040-1286-00

FIRMWARE ENHANCEMENT

For TEKTRONIX® 11802 Digital Sampling Oscilloscope

MANUAL CHANGE INFORMATION

Figure 3 - EPROM locations.

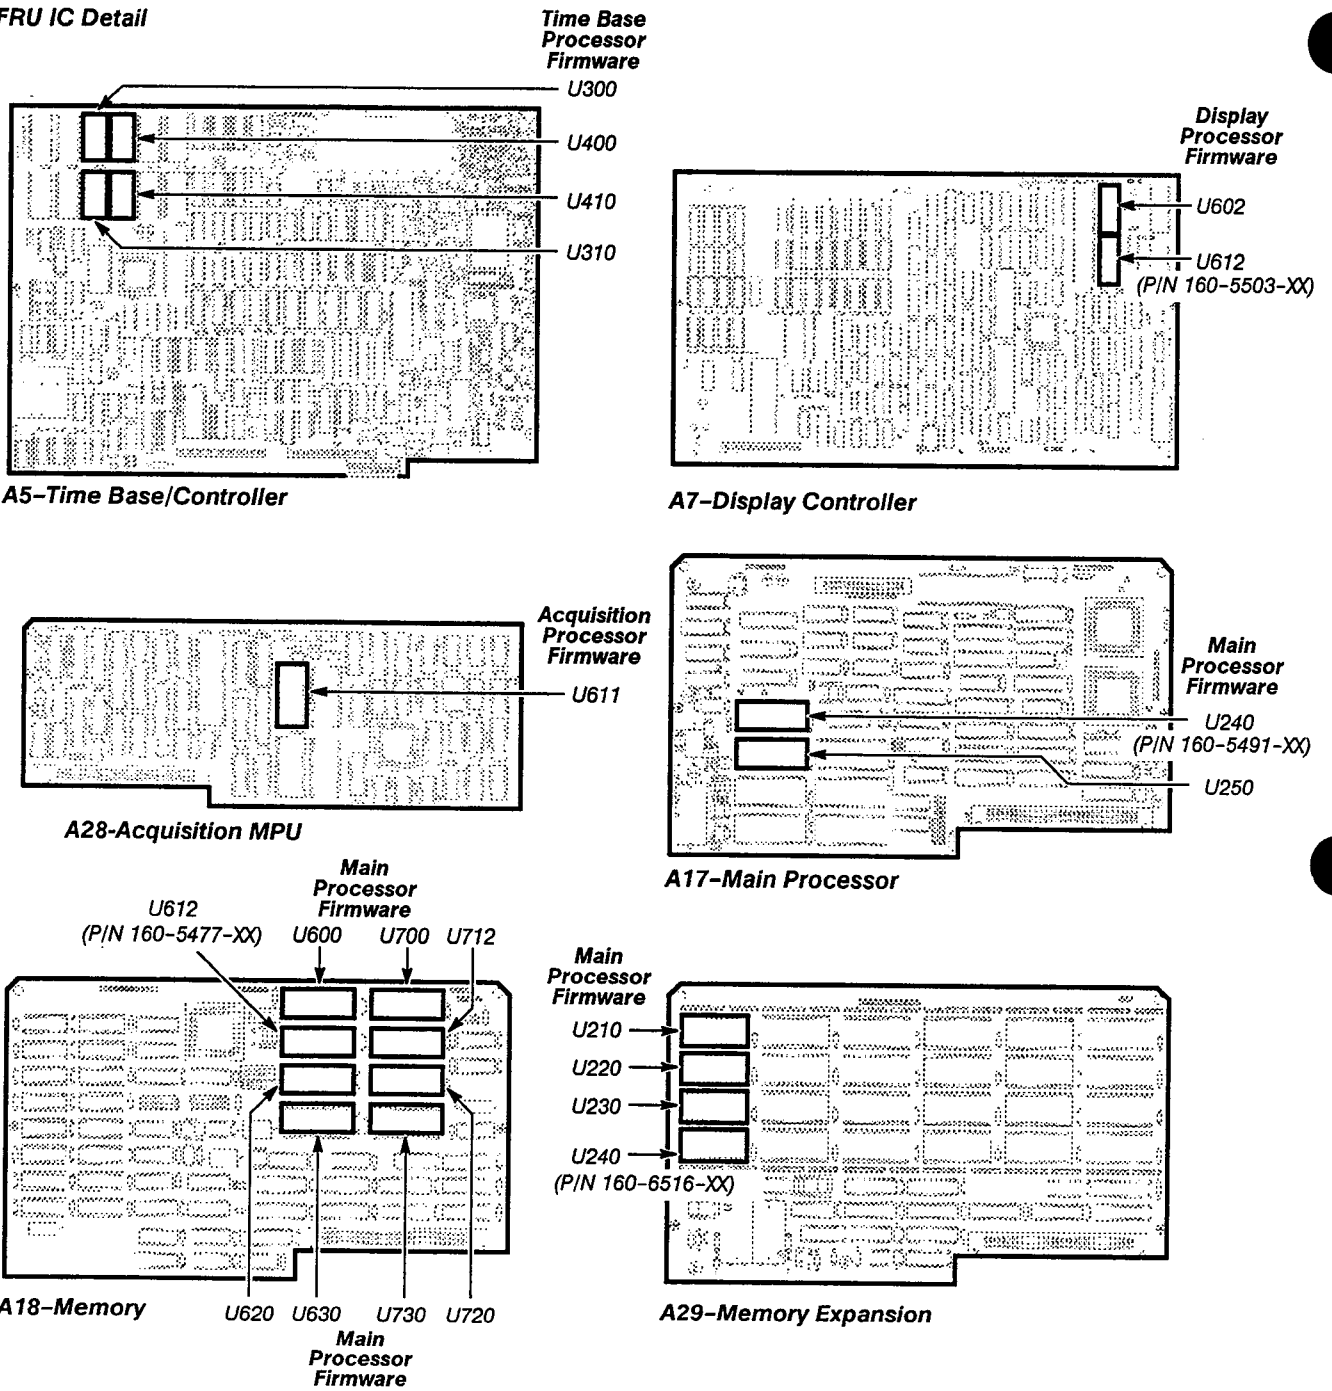
The last two-digit portion of the part number on the replacement EPROM's should be higher than that of the removed EPROM's Again, ensure that pin 1 is oriented correctly. Refer to Figure 3, for component locations.

- () 4. Remove the Memory circuit board A18 from the card cage.
- () 5. Replace the following microcircuits on the Memory circuit board A18 with the new microcircuits provided in this kit:

U600	160-5479-XX
U612	160-5477-XX
U620	160-5475-XX
U630	160-5473-XX
U700	160-5619-XX
U712	160-5478-XX
U720	160-5476-XX
U730	160-5474-XX

- () 8. Replace U210 and U220, microcircuits with the new microcircuits provided in this kit. Then install U230 and U240 microcircuits provided in this kit.

A29-Memory Expansion

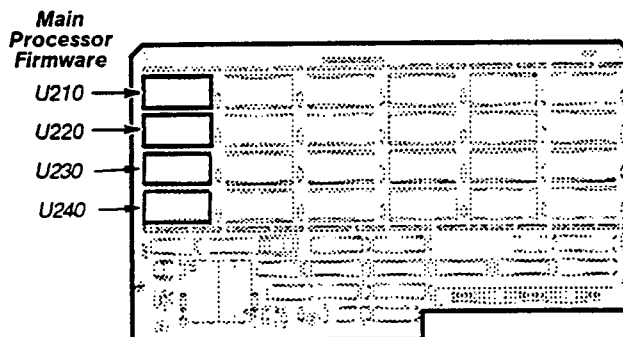
Maintenance, page 3-59, Figure 3-33, board **A29-Memory Expansion**, **ADD:** U230 and U240 as shown in the diagram below:

Step 2: On the A29 Memory Expansion board, replace ICs U210, U220, U230 and U240 (see Fig. 3-33 in this section).
